**CITY OF TEMPE
DEVELOPMENT REVIEW COMMISSION**

Meeting Date: 03/09/2016
Agenda Item: 3

ACTION: Request for Development Plan Review consisting of a new two-story office building for BUILDING A AT 2100 RIO SALADO, located at 2100 East Rio Salado Parkway. The applicant is Todd Lawrence of Butler Design Group.

BACKGROUND INFORMATION: BUILDING A AT 2100 RIO SALADO (PL150428) The site is located east of Tempe Marketplace on a former landfill that is being redeveloped in phases through a Planned Area Development approved by Council on January 15, 2015. Phase one is currently under construction and consists of two hotels. The second phase was proposed for retail and commercial uses at the east and west sides of the private drive aligned with the intersection of Rockford Drive and Rio Salado Parkway. This portion of the site has not yet applied for design entitlements, however the proposed phase three of the 24 acre site is requesting approval of the site plan, landscape plan and elevations for a new two-story office building. The request includes the following:

SITE PLAN

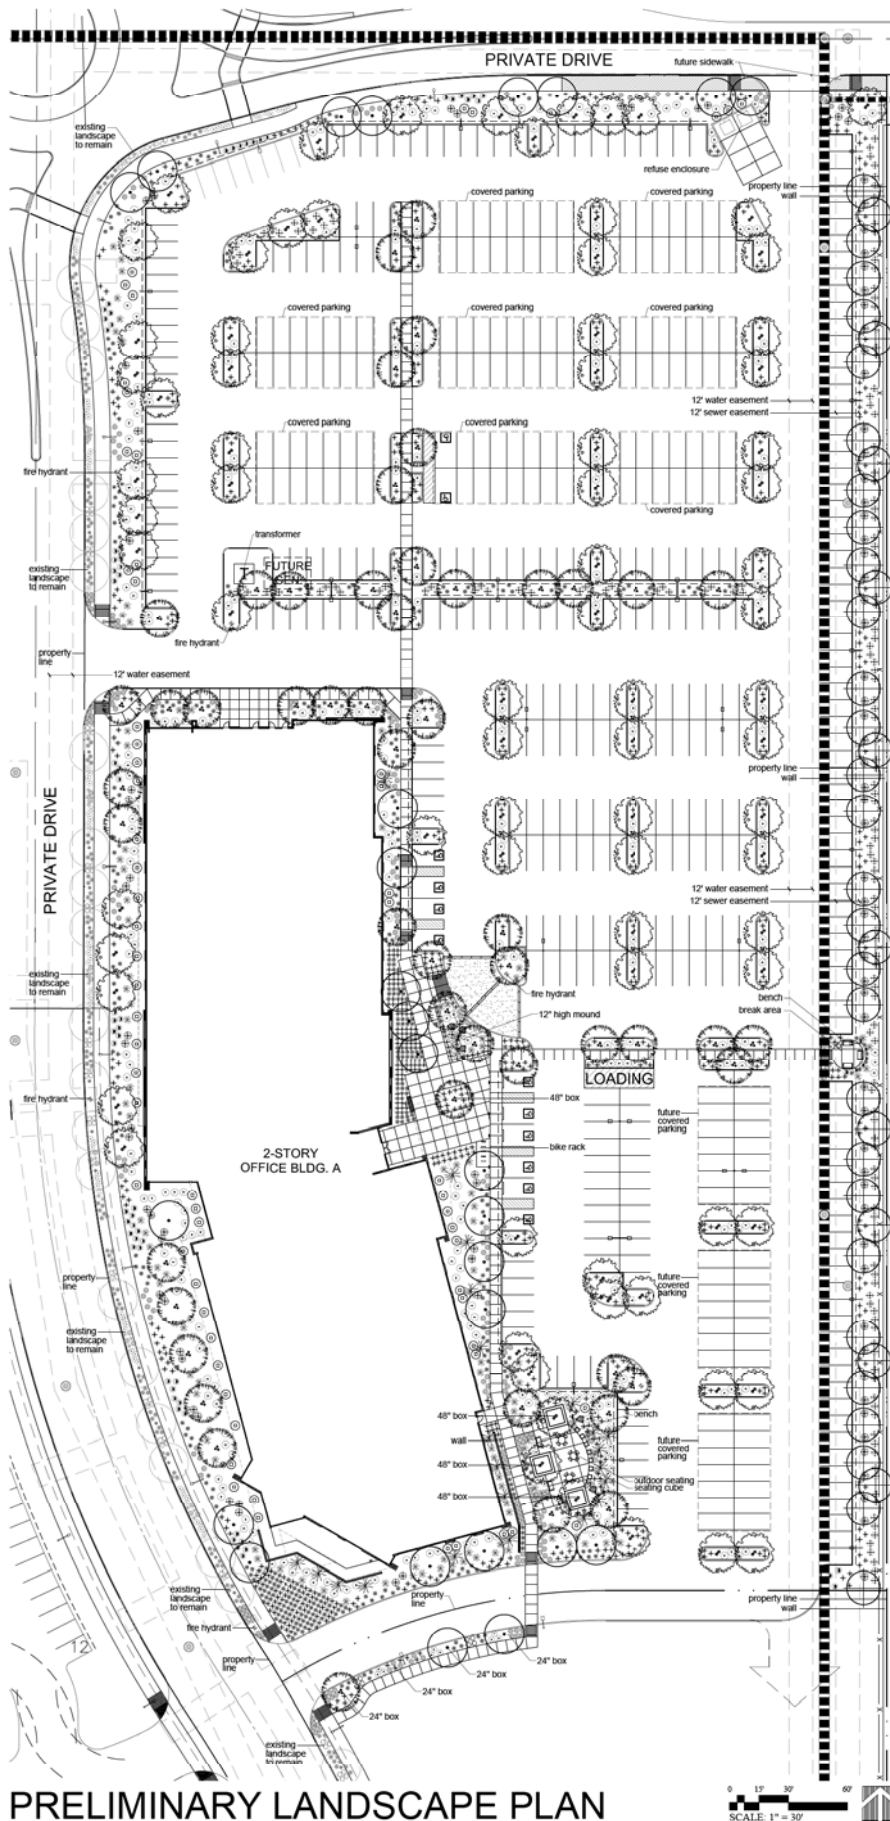
Site Plan

The site is a 7.14 acre portion of a phased 24 acre site divided by a private drive that aligns with Rockford Drive south of Rio Salado Parkway. The first phase hotels are under construction on the west side of the drive, this office building is on the east side of the drive, set back behind a future commercial pad at the Rio Salado Parkway frontage. The building is pushed to the east of the lot, closest to the private drive, to screen the parking and provide easier pedestrian access to the hotels across the street, and future commercial to the south; creating a campus-like setting along the private drive. The building is rectilinear, oriented north to south along the narrow ends and the longest elevations being east and west oriented. The building has a bend in the form to follow the curvature of the road and to break the rectangular form. An amenity area on the south east side of the building provides a shaded ground floor gathering area for employees to use on breaks. The primary entrance to the building is centered on the eastern elevation, with a secondary entrance on the north side serving employees from the covered parking lot to the north. The surface parking is shaded by trees and shade canopies. The driveway to the south of the building aligns with the hotel drive, and is shared with the commercial lot to the south. Two other access drives are available, one further north on the site adjacent to the parking area, just south of a round about for the future northern developments; the other drive is at the north east corner of the lot, serving refuse and fire access, as well as future connectivity to the lots to the north of this site, which are planned for additional offices.

2. Provide service locations as shown on the January 29, 2016 plan for both refuse and recycling collection and pick-up on the property. Coordinate the storage areas for refuse and recycling containers with the overall site and landscape layout.

3. Provide service yard and mechanical yard walls that are at least 8'-0" tall as measured from adjacent grade and are at least the height of the equipment being enclosed, whichever is greater. Verify height of equipment and mounting base to ensure that wall height is adequate to fully screen the equipment.

4. Provide gates of steel vertical picket, steel mesh, steel panel or similar construction. Where a gate has a screen function and is completely opaque, provide vision portals for visual surveillance. Provide gates of height that match that of the adjacent enclosure walls. Review gate hardware with Building Safety and Fire staff and design gate to resolve lock and emergency ingress/egress features that may be required.

PRELIMINARY LANDSCAPE PLAN

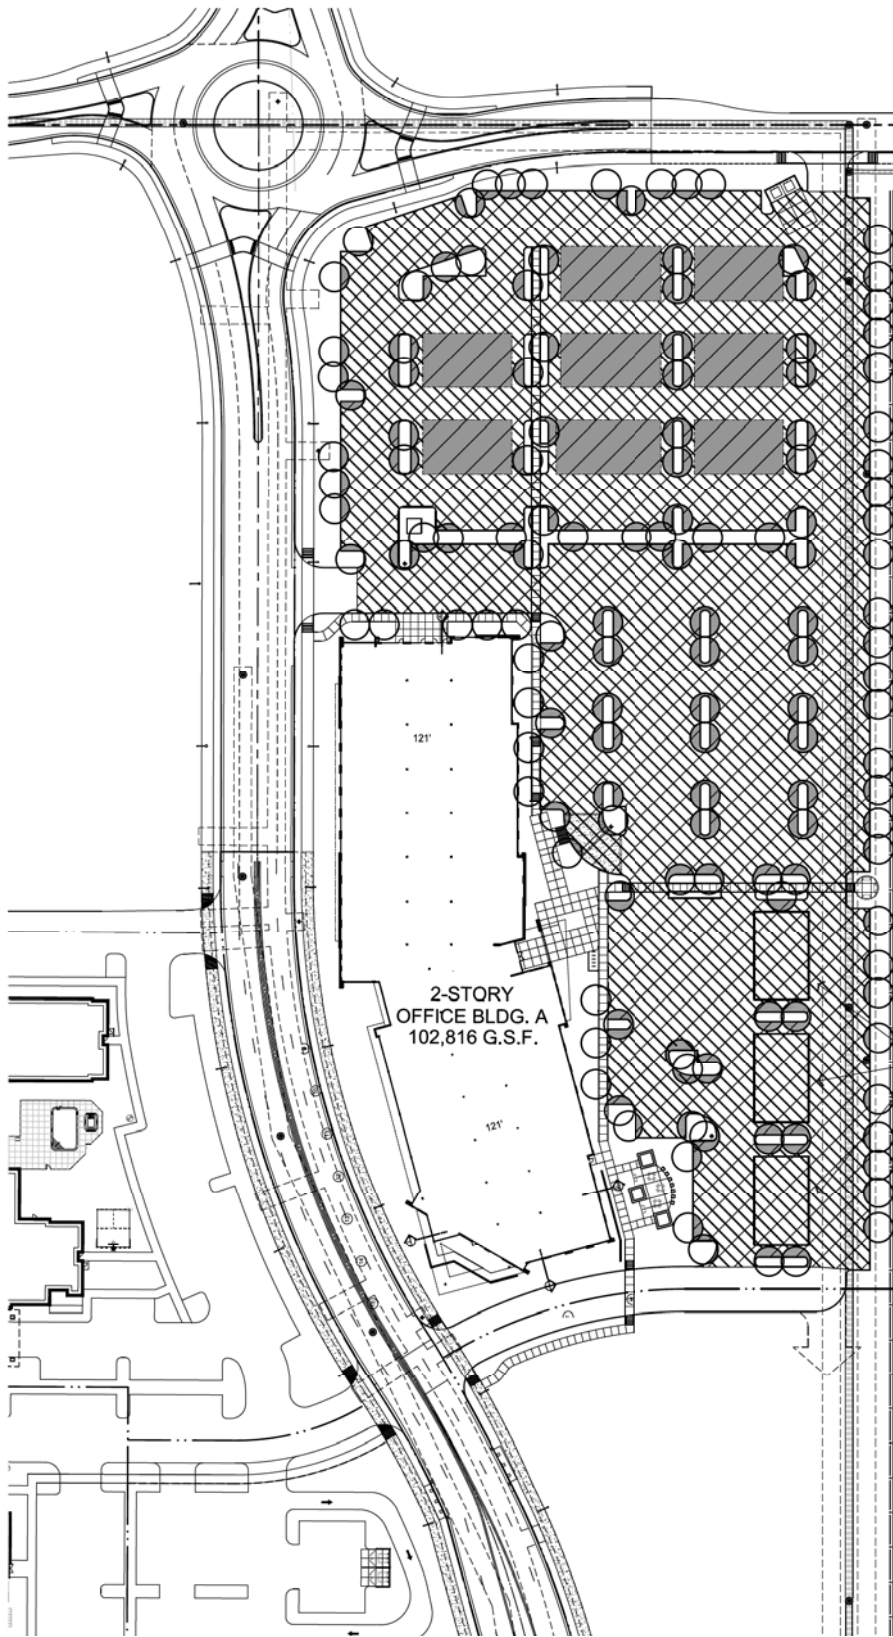
Landscape Plan

The 7 acre site was deep impact compacted and capped as part of the landfill closure process. As a result, the site is limited to what type of plant materials may be used to minimize water percolation into the lower soil levels. Low water use desert plants provide the palette for the site, in a relatively high density of tree coverage. The private drive is lined with Desert Museum Palo Verde and Thornless Hybrid Mesquite. The Mill and Lake District Streetscape Principles and Guidelines indicate this area as part of the Riparian Transition Zone, using Thornless Chilean Mesquite as the primary street tree, Sonoran Desert Museum Palo Verde as the secondary tree, and Honey Locust for third level tree plantings, other trees can be used on site or as accents, but these are the preferred species. The trees along the east side of the building are Southern Live Oak. The trees along the eastern property edge are Sissoo trees, providing a dense canopy of year-round leaf coverage. Mesquites are used along pedestrian paths, oriented to maximize shade to pedestrian areas, and Palo Verde is used in landscape islands adjacent to the shade canopies in the parking areas.

16. The plant palette is approved as proposed and specified on the landscape plan. Any additions or modifications may be submitted for review during building plan check process.

17. Irrigation notes:
 - a. Provide dedicated landscape water meter.
 - b. Provide pipe distribution system of buried rigid (polyvinylchloride), not flexible (polyethylene). Use of schedule 40 PVC mainline and class 315 PVC ½" feeder line is acceptable. Class 200 PVC feeder line may be used for sizes greater than ½". Provide details of water distribution system.

18. Include requirement to de-compact soil in planting areas on site and remove construction debris from planting areas prior to landscape installation.

19. Top dress planting areas with a rock or decomposed granite application. Provide rock or decomposed granite of 2" uniform thickness. Provide pre-emergence weed control application and do not underlay rock or decomposed granite application with plastic.

20. Trees shall be planted a minimum of 20'-0" from any existing or proposed public water or sewer lines. The tree planting separation requirements may be reduced from the waterline upon the installation of a linear root barrier, a minimum of 6'-0" parallel from the waterline, or around the tree. The root barrier shall be a continuous material, a minimum of 0.08" thick, installed 0'-2" above finish grade to a depth of 8'-0" below grade. Final approval subject to determination by the Public Works, Water Utilities Division.

BUILDING ELEVATIONS

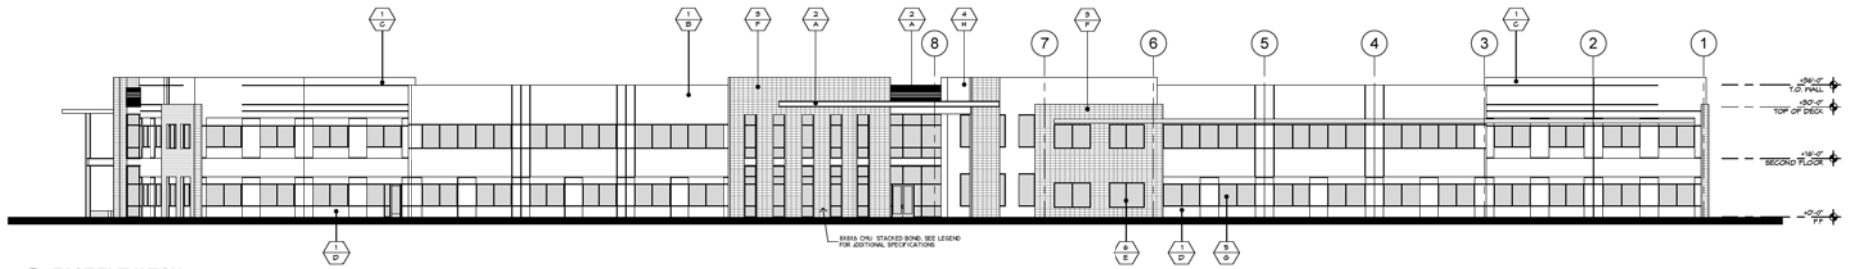
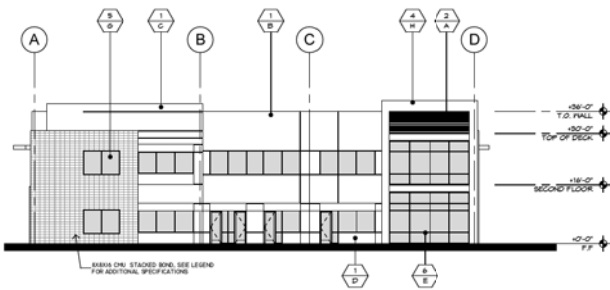
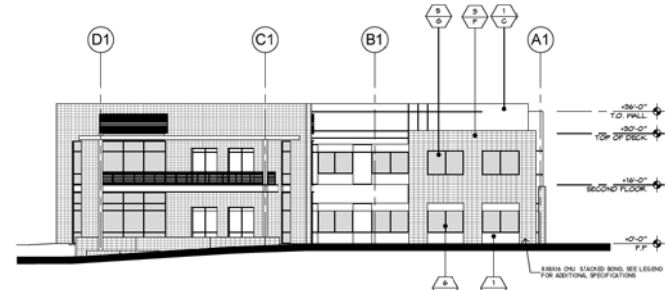
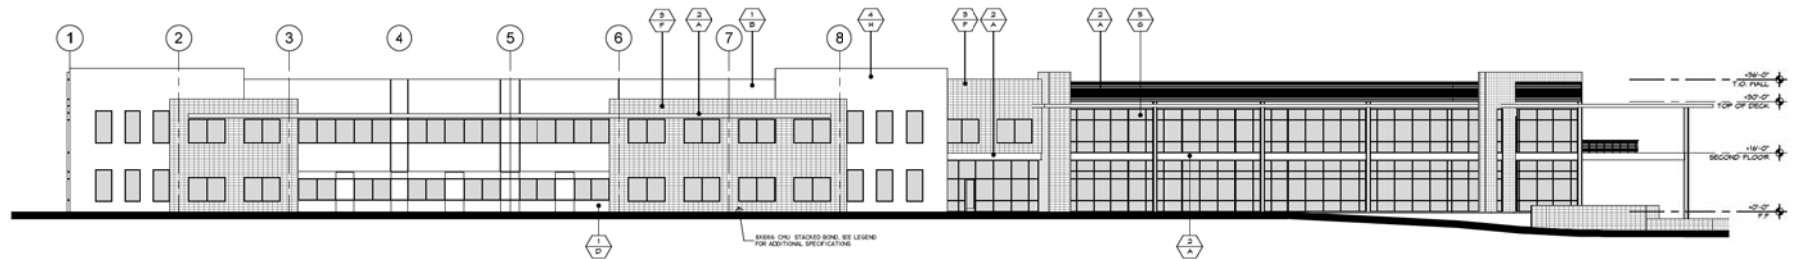
Building Elevations

The building has a variety of materials used on all four sides to add variation and visual interest to the site. The predominant material is painted tilt-slab concrete walls, broken by 8"x8"x16" integral colored cmu grouted in a contemporary stacked bond pattern. Large panel ceramic tiles accent the building in a mottled medium brown color that provides a rusted patina corten steel look with the durability of a product that will not run or stain adjacent materials. The product color name is steel corten,

this is not the product material; it is a ceramic tile product. The combinations of light and medium warm-grey tones, the ceramic tile, dark metal railings and awnings, and aluminum storefront glazing provide variation to the elevations. A deep overhang on the south west side shades the commercial windows and a large patio accessible to employees. The elevations have projected shade canopies, portions of the building are recessed or projecting from the main building, and varied in height along the flat parapet roof to break up the building massing. Windows are taken on different shapes and sizes along the elevations, to become a building defining element between the walls of the structure, with changes in color along the wainscot and lintels of the windows. This will be the first new office building within the area, and sets the vision for the remainder of the commercial uses on site.

9. The materials and colors are approved as presented (January 29, 2016):
 - Roof – flat with parapet
 - Primary Building – Tilt Slab Concrete painted Dunn Edwards Muslin DE6227 (off-white)
 - Secondary Building – Tilt Slab Concrete painted Dunn Edwards Play on Gray DE6228 (medium warm grey)
 - Masonry - 8"x8"x16" Trenwyth Trendstone honed integral colored CMU Pebble Beach
 - Tile - 3' x 9' Levantina Techlam Ceramic Tile color Steel Corten
 - Building Accent – Dunn Edwards Calico Rock DE6229 (medium warm grey)
 - Windows - Anodized aluminum frame – tinted blue-grey low-E rated
 - Painted steel – Dunn Edwards Charcoal Sketch DET628 (dark warm grey)

Provide primary building colors and materials with a light reflectance value of 75 percent or less. Additions or modifications may be submitted for review during building plan check process.
